APPLICATION NO.	FILE	NG DATE	FIRST NAMED INVENTOR	ATTORNEY DOCKET NO.	CONFIRMATION NO.	
10/098,721	03/18/2002		David Joel Maker		5237	
7	1590	06/30/2003				
David Maker				EXAMINER		
7807 Hilton Dr. Huntsville, AL 35802				KIM, TA	E JUN	
				ART UNIT	PAPER NUMBER	
				3746	н	
				DATE MAILED: 06/30/2003	7

Application No.	Applicant(s)
	10/098,721	MAKER, DAVID JOEL
Office Action Summary	Examiner	Art Unit
	Ted Kim	3746
The MAILING DATE of this communication app Period for Reply	ears on the cover sheet with the c	correspondence address
A SHORTENED STATUTORY PERIOD FOR REPLY THE MAILING DATE OF THIS COMMUNICATION. - Extensions of time may be available under the provisions of 37 CFR 1.13 after SIX (6) MONTHS from the mailing date of this communication. - If the period for reply specified above is less than thirty (30) days, a reply If NO period for reply is specified above, the maximum statutory period w Failure to reply within the set or extended period for reply will, by statute, Any reply received by the Office later than three months after the mailing earned patent term adjustment. See 37 CFR 1.704(b). Status	36(a). In no event, however, may a reply be time within the statutory mini

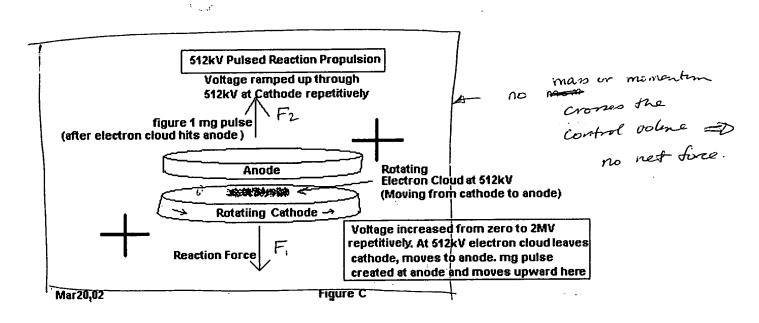
Furthermore, taking a control volume about Figure C, conservation of momentum shows that for the entire system, as there is no mass transfer through the boundaries of the control volume, there is no net force provided to the system. As the electron cloud goes from cathode to anode, the momentum of the electron cloud leaving the cathode

leaves a reaction force on the rotating cathode. The momentum of the electron cloud hitting the anode results in the same reaction force but in the opposite direction. Consequently, there is no net reaction force on the system and location of the center of gravity of the system will not change. Hence, applicant has yet to show how thrust will be achieved for a system.

F₁ = F₂ => no net Sorce as morrorton is conserved : ' lay
